Soil angles for shipment of uranium metal 7/1/62

Conclusions: a. In which Muller's calc. - see 2/6/62 letter

REFER TO SKETCH OF 22 UNIT ARRAY IN TRUCK

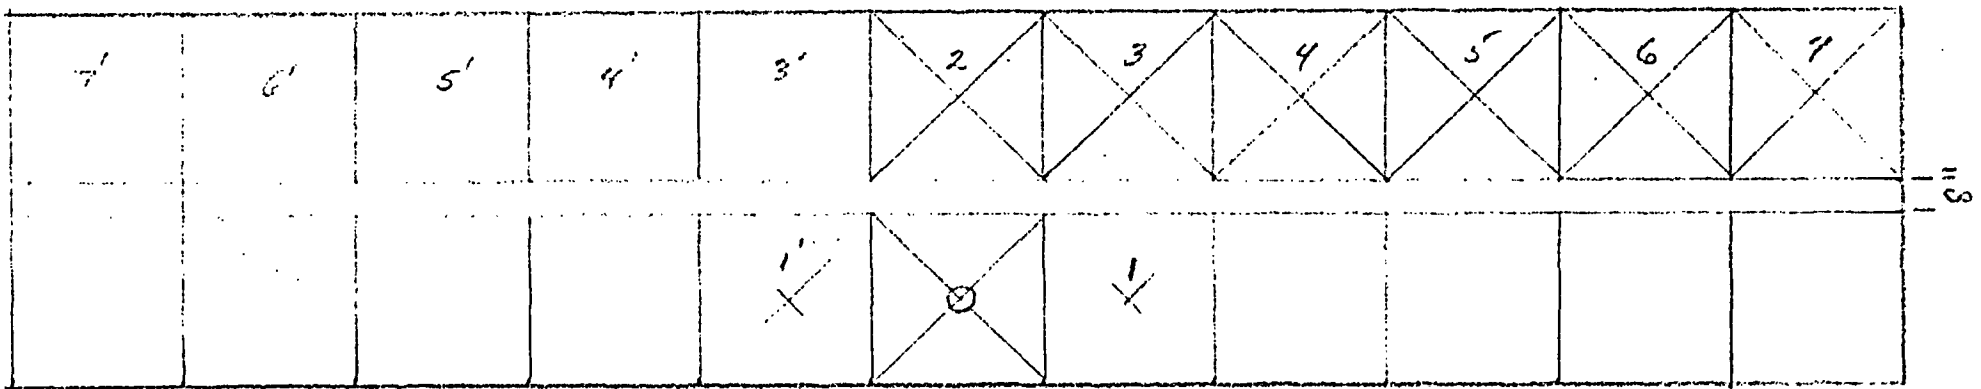
\* MALLINCKRODT SOMEWHAT HIGHER IN COMPUTED SOLID ANGLE BECAUSE:

(1) Method of K-1309 is non-conservative by as 5% in this range (Values of  $\Omega$  too low in comp. with  $\frac{2d \sin \theta}{r}$ )

NO | (2) I used ~~3' 7" side dimension of linkage~~ (in TIV-1011) whereas Mill used ~~5' 6"~~ used 6"

(3) I assumed cages along sides of truck (see sketch) with 8" blocks separating rows. Makes  $\Omega$  to 2, 3, 4, 5, 6 and 7 a little lower. To drums 1 and 1' I reversed to no cage sep., giving  $\Omega = .916$
